L160-D961646-E-V DEC 19 1996
 PSI DWG # V049-8-530

PART LIST		MATERIAL SPECIFICATION 304 SST	
UNLESS OTHERWISE SPECIFIED DIMENSIONS ARE IN INCHES TOLERANCES ARE: DECIMALS ANGLES FINISH X.X ± .03 ± 10° 12° X.XX ± .010 X.XX ± .01 WITHIN .05 UNDRIPPED FILLER 45° BREAK EDGES 45° ± 5° REMOVE ALL BURRS		CONTRACT OR SALES ORDER NO. APPROVALS DATE DRAWN BY CHECKED BY DATE	
THIRD ANGLE PROJECTION DO NOT SCALE DRAWING CADD FILE NAME USED ON		 GNB Corporation SCIENTIFIC AND INDUSTRIAL EQUIPMENT 30871 San Benito Court HAYWARD, CALIFORNIA 94544 (510) 441-1900 FAX: (510) 441-0830 TITLE GATE FRAME WELDMENT G44 DWG. NO. 103228 SCALE: NONE SHEET 1 OF 1

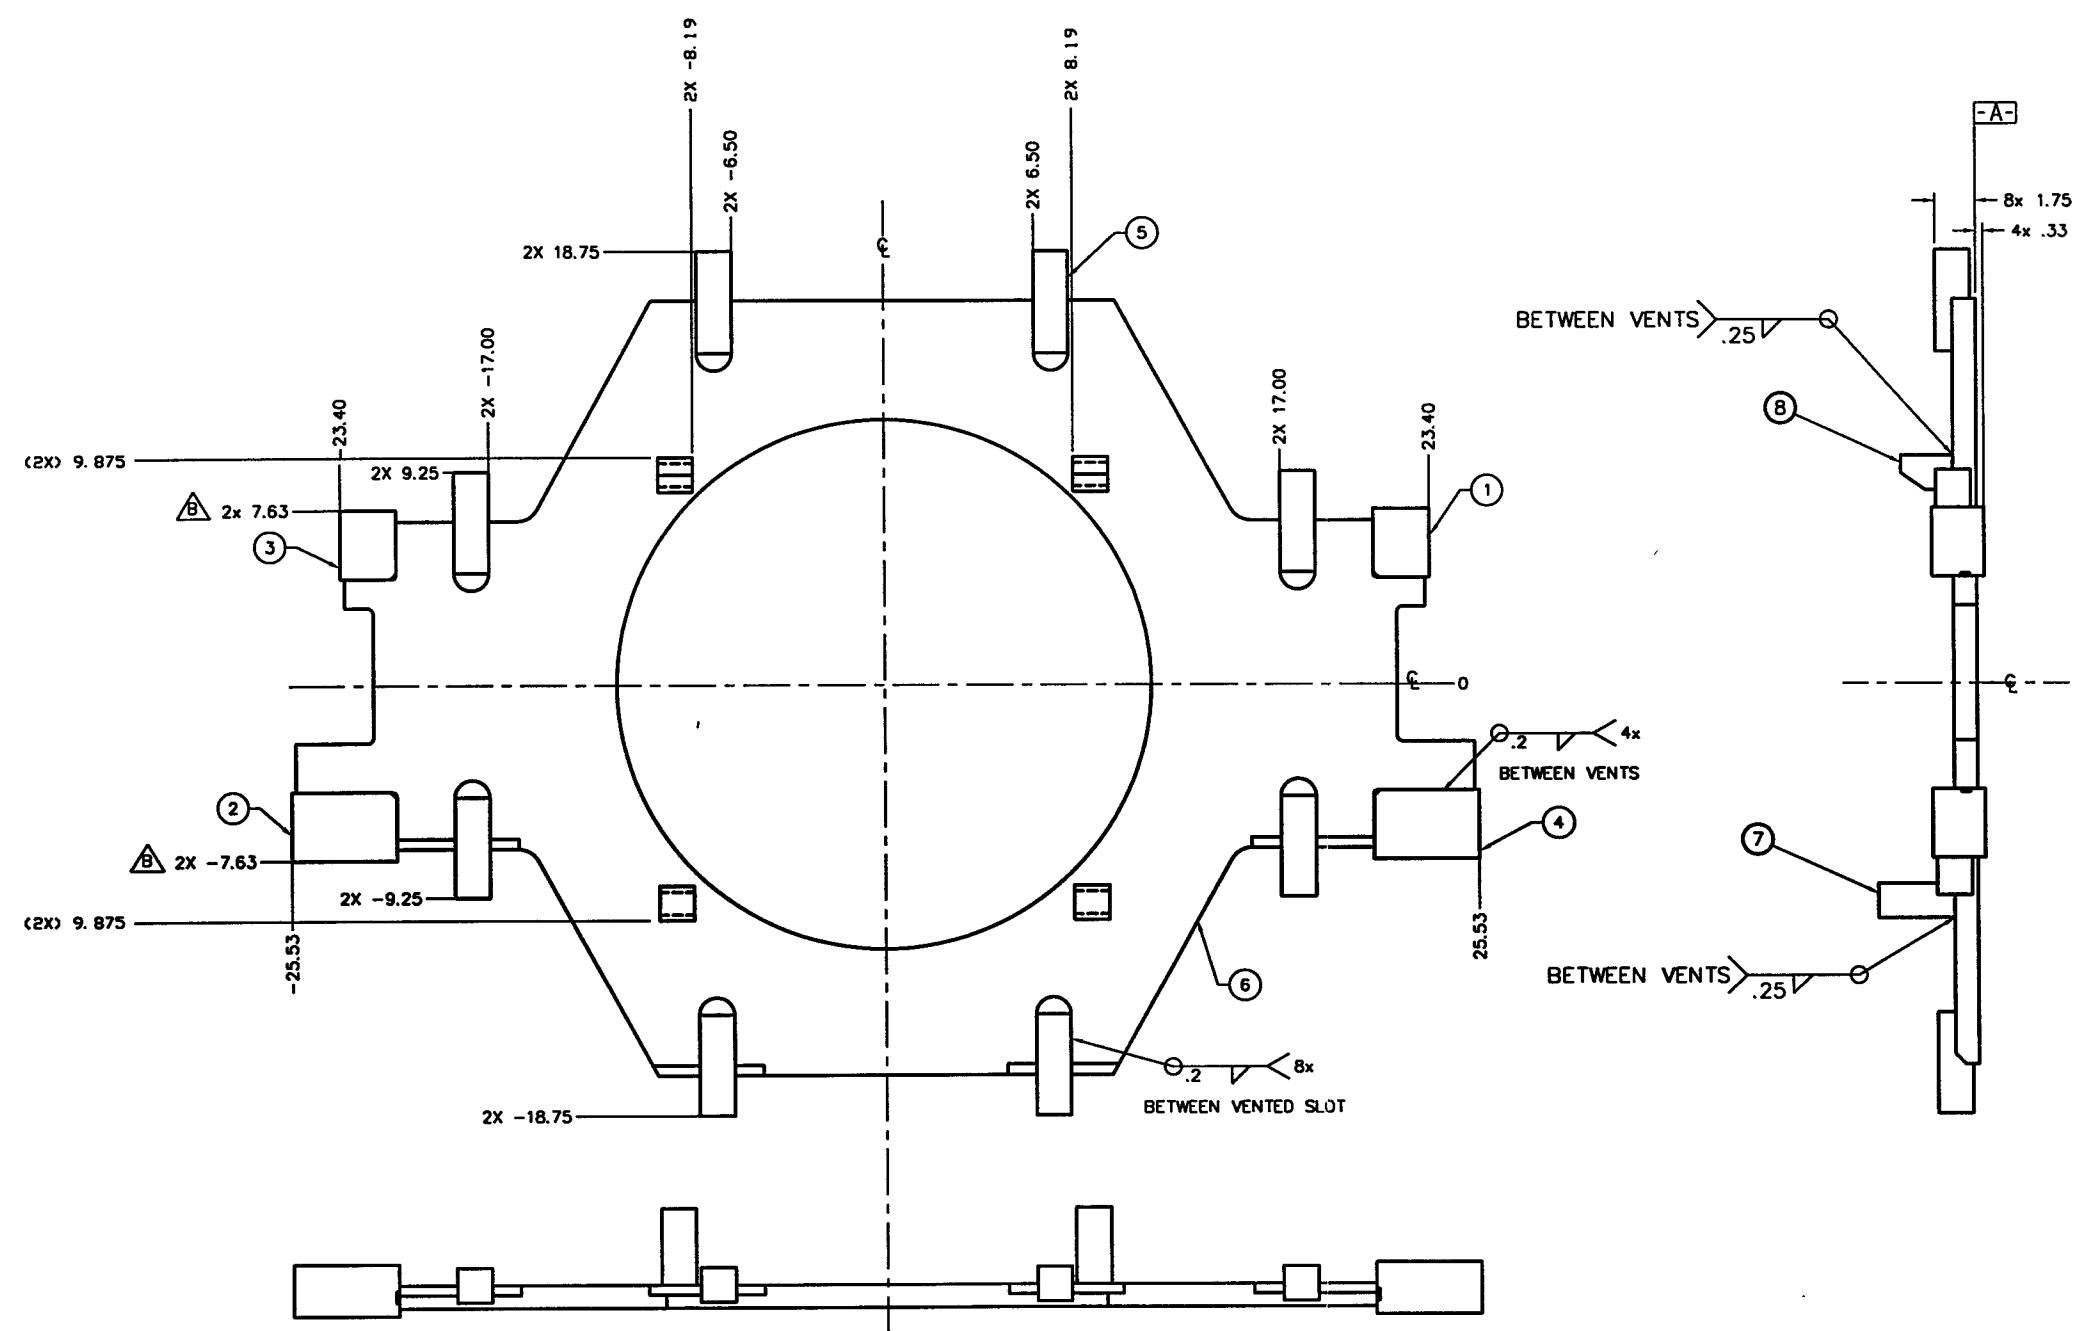
REV.	DESCRIPTION	APPROVED	DATE
A	RELEASED		
B	ADD 7.63, REMOVE STIFFENERS		1-27-96
C	ADDED THE WELD DETAIL		
D	REMOVED WELD DETAIL; ADDED ITEMS 7 & 8 TO B.O.M.; ADDED NOTE; REDRAWN SHOWING RELIEF FOR LINKS	A.L.	10/28/96
E	REDRAWN SHOWING ITEMS 7 AND 8	A.L.	11-19-96
